NEEDHAM PLANNING BOARD

Tuesday, August 27, 2024 7:00 p.m.

Amendment to Major Project Site Plan Special Permit No. 2011-04: Town of Needham, 1471 Highland Avenue, Needham, MA, Petitioner (Property is the location of the Center at the Heights, 300 Hillside Avenue, Needham, Massachusetts). Regarding request for the installation of a permanent emergency generator to serve the Center at the Heights as well as a reduction of 3 parking spaces.

Re: Request to Amend Major Project Site Plan Special Permit No. 2011-04
The Center at the Heights

Figure 1 - Site Plan Showing Proposed Generator Location G, and Residential Receptors R1, R2, etc.

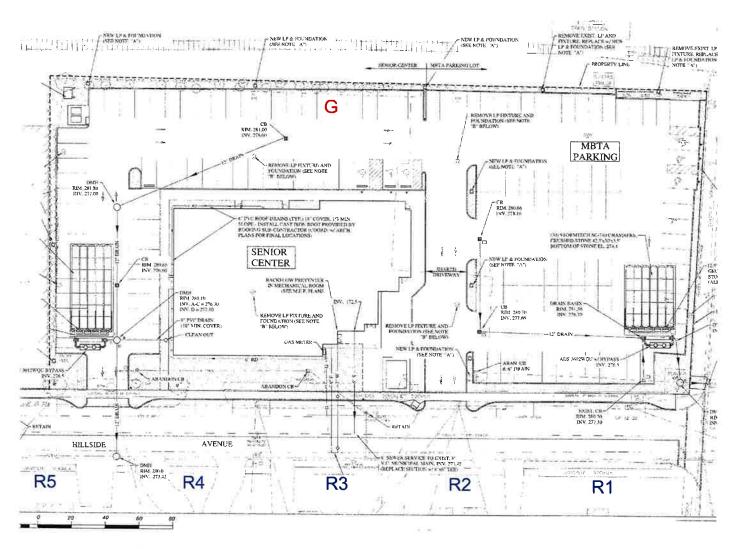
- When the make and model of the generator is determined, a noise study needs to be conducted prior to issue of building permit.
- Fencing needs to be shown around the generator for a visual and sound attenuation barrier.
- We have no objection or comment to the parking spaces occupied where the generator is proposed.
